Economic Commission for Europe**Inland Transport Committee****World Forum for Harmonization of Vehicle Regulations****Working Party on General Safety Provisions****125th session**

Event Data Recorder:**Guidance on Event Data Recorder****Performance Elements Appropriate for Adoption in****the 1958 and 1998 Agreements Resolutions or Regulations****Proposal for Amending the Guidance on Event Data Recorder
Performance Elements****Submitted by the expert from the Informal Working Group on Event
Data Recorder / Data Storage System for Automated Driving ***

Corridor +/- 10 Per Cent of the Full-Scale Range of the Accelerometer

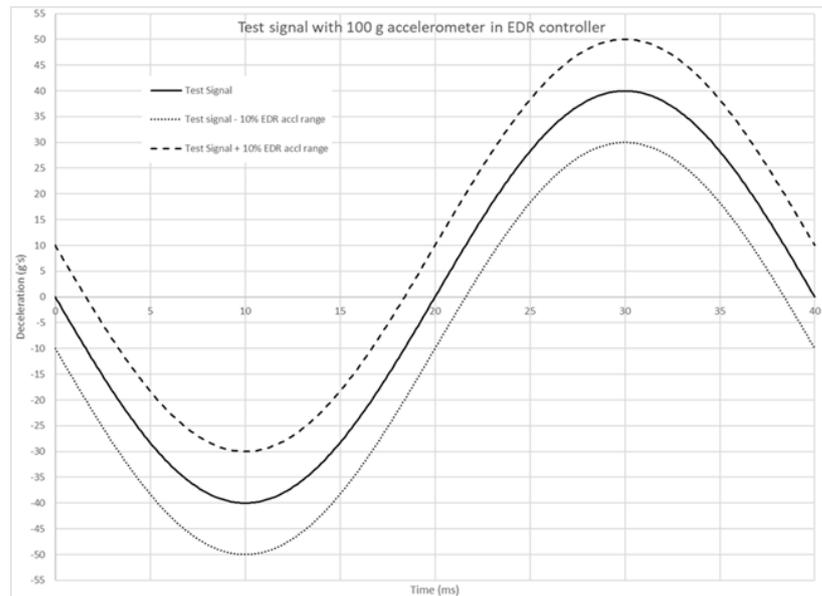
- 4.1.5. The EDR recorded acceleration trace shall be fully contained in a corridor that is +/- 10 per cent of the full-scale range of the accelerometer used by the controller containing the EDR applied to the component test fixture's filtered acceleration trace. The comparison of acceleration sensor traces shall only be made on the axis the component test was conducted.

For example, if the accelerometer in the controller containing the EDR function has a +/- 100 g range, then +/- 10 g would be applied to the component test fixture's filtered acceleration trace. The EDR recorded acceleration trace shall be fully contained within that corridor (see the Figure).
